Form 3160-5
(June 2019)UNITED STATES
DEPARTMENT OF THE INTERIOR
BUREAU OF LAND MANAGEMENTFORM APPROVED
OMB No. 1004-0137
Expires: October 31, 2021**SUNDRY NOTICES AND REPORTS ON WELLS**
Do not use this form for proposals to drill or to re-enter an abandoned well. Use Form 3160-3 (APD) for such proposals.

8. Well Name and No. ROSS DRAW 17 FED COM/706H

EOG respectfully requests an amendment to our approved APD for this well to reflect the following changes:

Revised Permit Information 06/08/2022:

WELL LOCATION AND ACREAGE DEDICATION PLAT

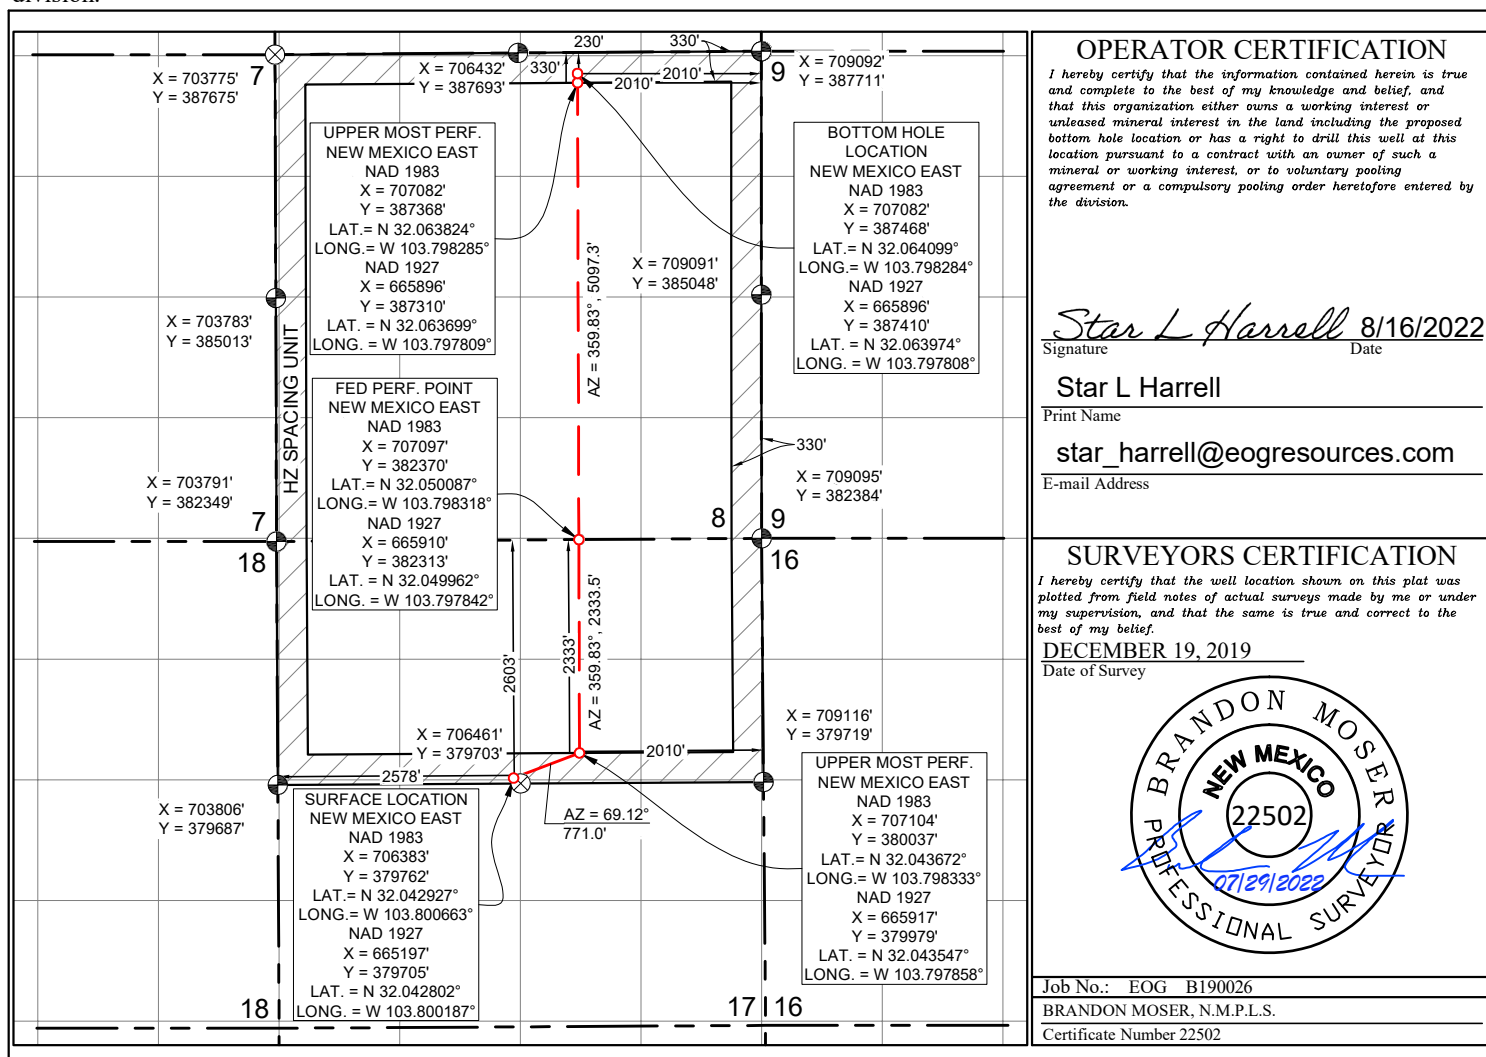
Change SHL from T-26-S, R-31-E, Sec 17, 2646' FNL, 693' FEL, Eddy Co., NM, to T-26-S, R-31-E, Sec 17, 2603' FSL, 2578' FWL, Eddy Co., N.M.

Update HSU to 960 acres.

UL or lot no.	Section	Township	Range	Lot Idn	Feet from the	North/South line	Feet from the	East/West line	County
F	17	26 S	31 E		2603	NORTH	2578	WEST	EDDY

UL or lot no.	Section	Township	Range	Lot Idn	Feet from the	North/South line	Feet from the	East/West line	County
B	8	26 S	31 E		230	NORTH	2010	EAST	EDDY
Dedicated Acres 960.00	Joint or Infill	Consolidated Code	Order No.

Revised Wellbore

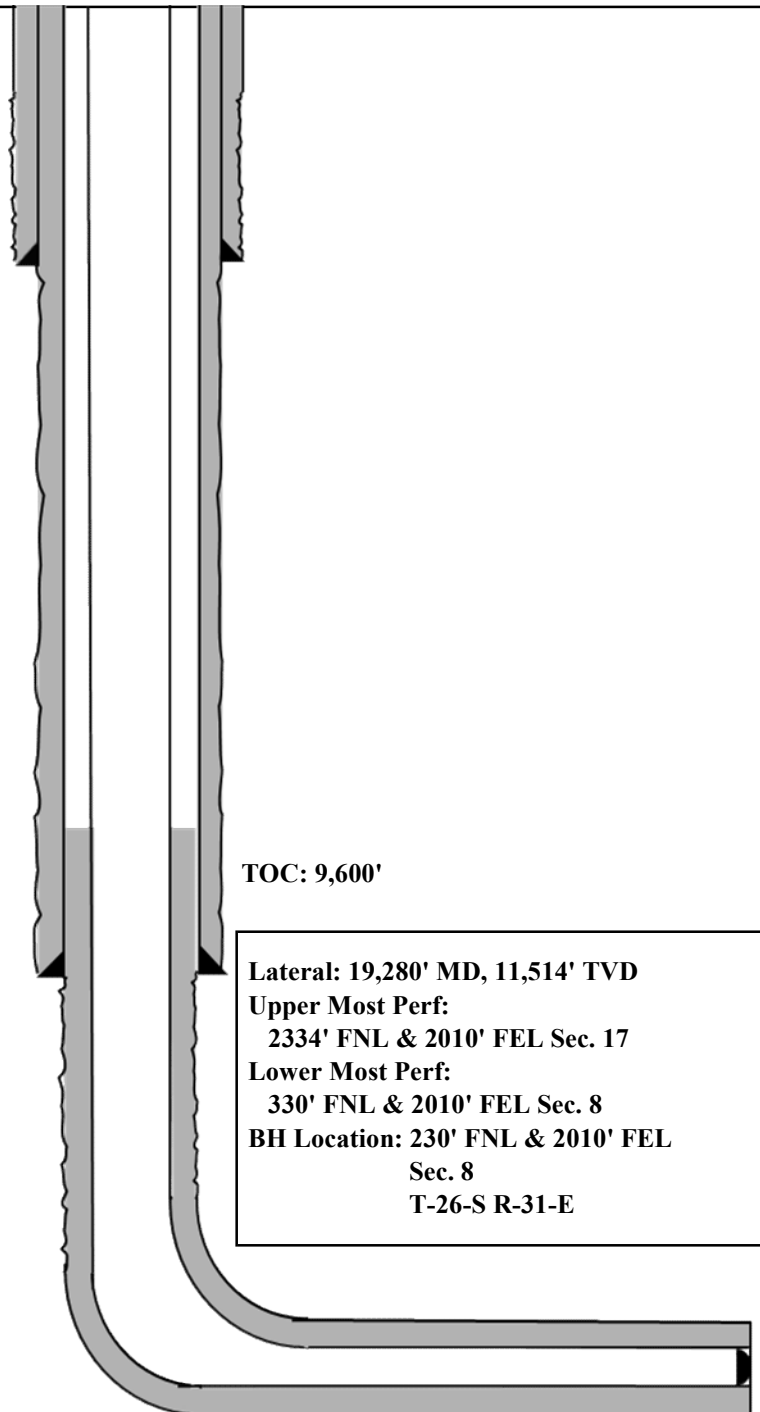
Update casing and cement program to current design.

Bit Size: 12-1/4"
9-5/8", 36#, J-55, LTC,
@ 0' - 1,310'

Bit Size: 8-3/4"
7-5/8", 29.7#, HCP-110, FXL,
@ 0' - 10,100'

Bit Size: 6-3/4"
5-1/2", 20#, P110-EC, DWC/C IS MS,
@ 0' - 9,600'

5-1/2", 20#, P110-EC, Vam Sprint SF,
@ 9,600' - 10,100'

5-1/2", 20#, P110-EC, DWC/C IS MS,
@ 10,100' - 19,280'
